TDX CONSTRUCTION CORPORATION

August 11, 2000

RE: *Baruch College - Site "B"*  
Minutes of Meeting on Escalators  
& Public Stair #3

The purpose of this meeting is to address architectural details relating to the escalators and to public stair #3. The following constitute what was discussed:

2nd Floor RCP

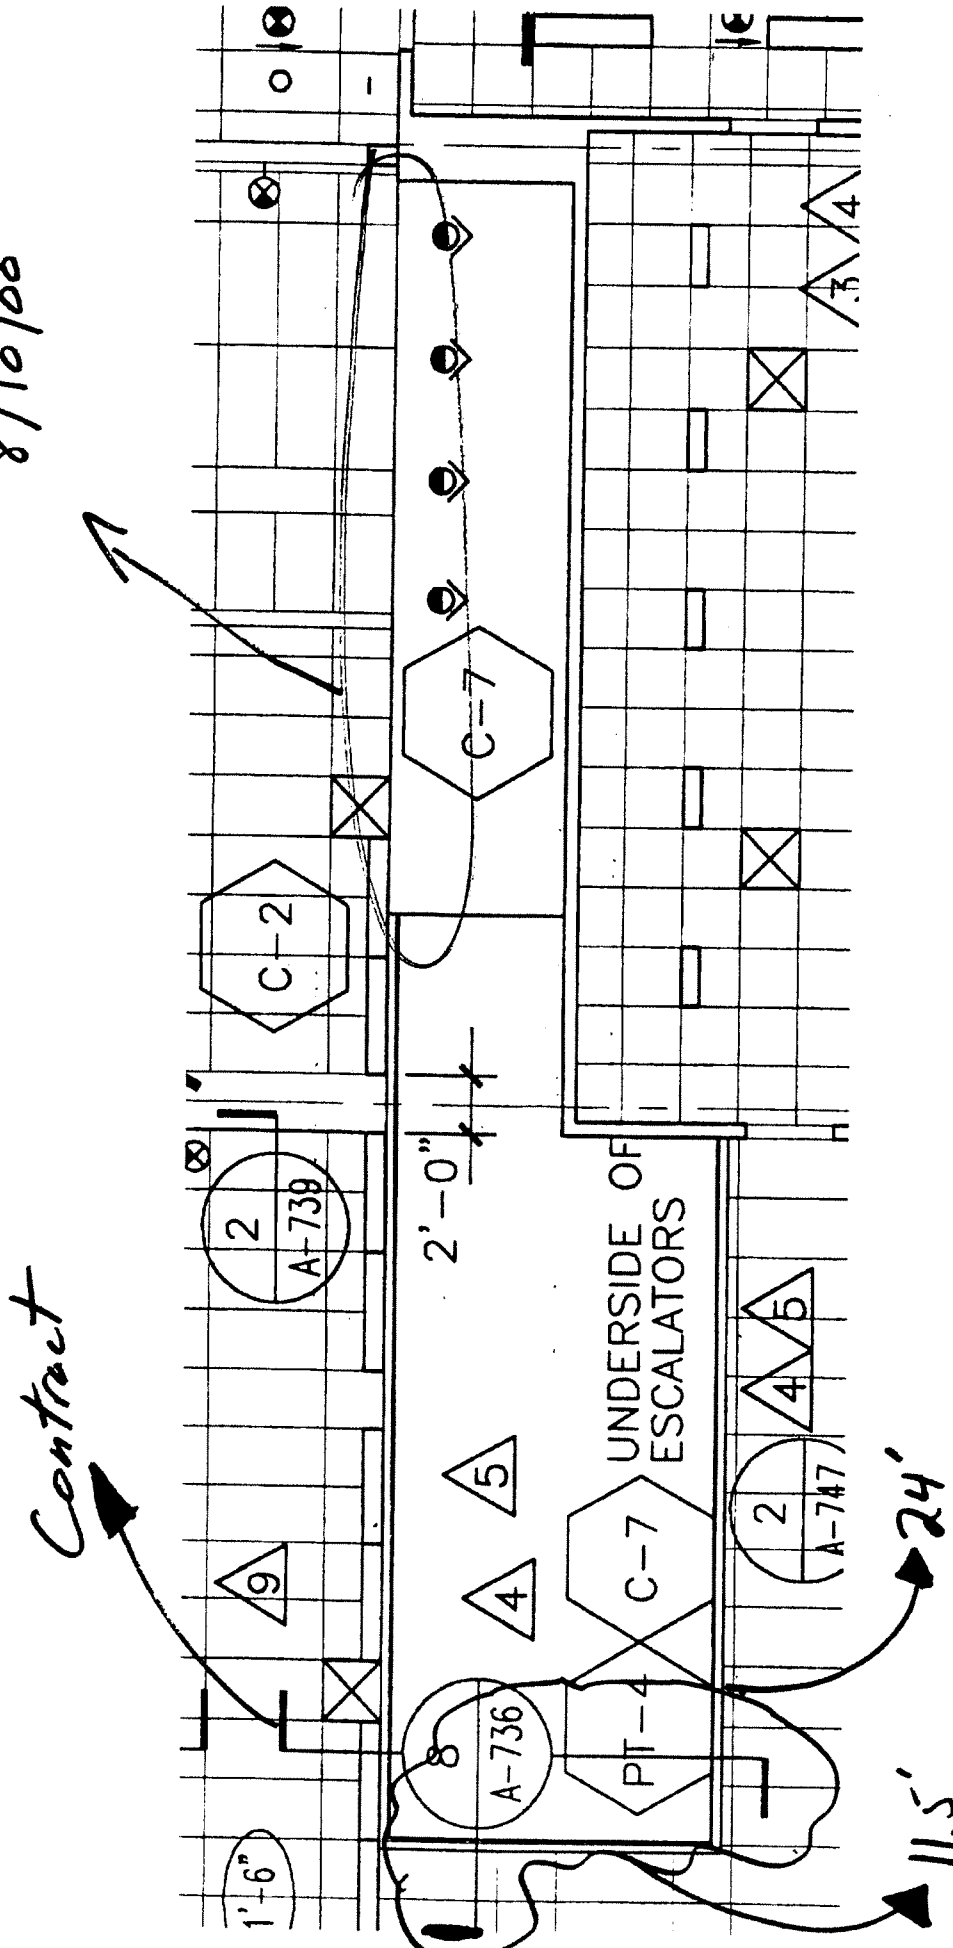
- Finished cladding shall be 5" from the bottom of the escalator truss to accommodate the sprinkler piping.
- Cladding shall terminate 3 1/2" from each end of the truss and 5" down from the bottom of the lowest adjacent truss. On the second floor, the cladding shall terminate 3 1/2" from the shortest of the (2) trusses on the eastside.

- The depth of the sheetrock ceiling soffits will vary depending on finished ceiling heights and the underside of the cladding.
- The draft stop shall extend to column line 8 on the 2<sup>nd</sup> floor and from the lay in ceiling to column line 8 on the 3<sup>rd</sup> and 4<sup>th</sup> floors.

# Bulletin # 26

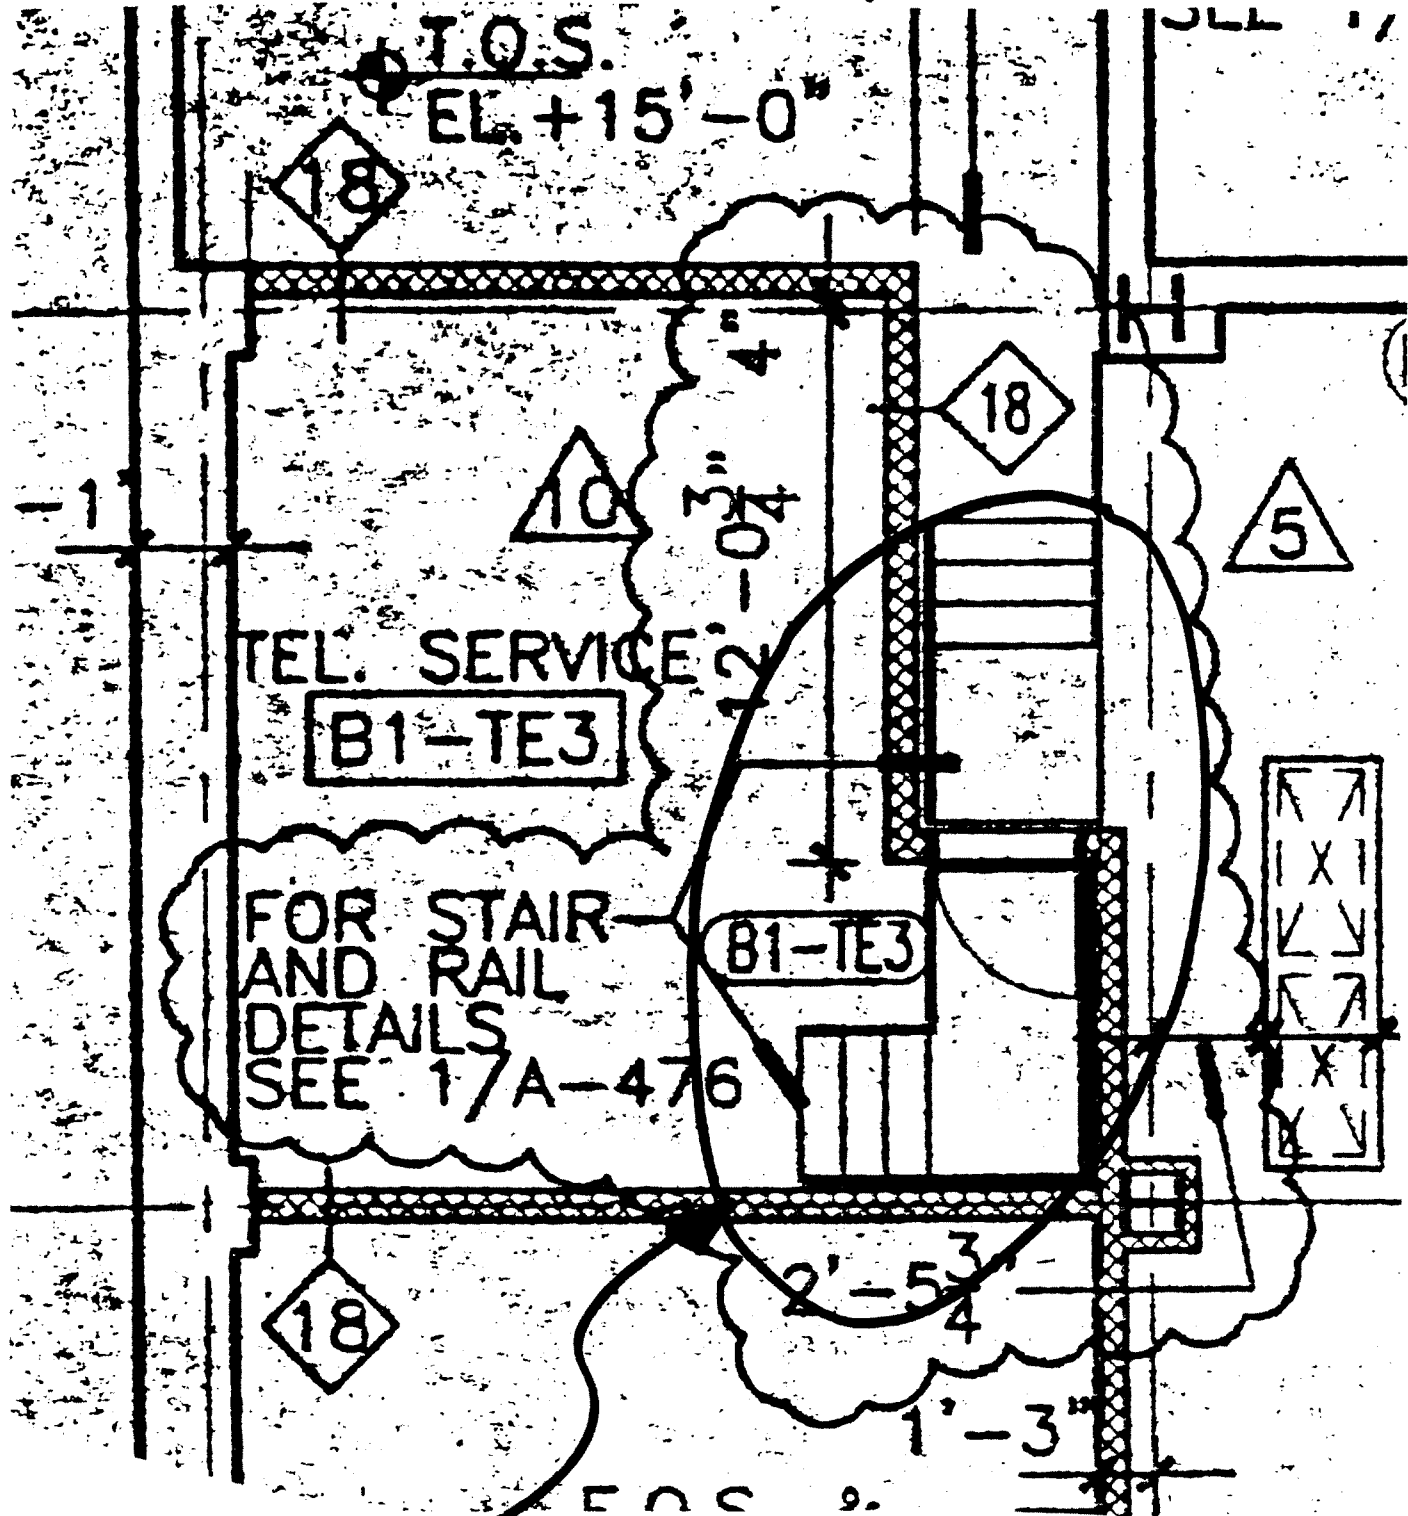
Change to  
L-Shaped
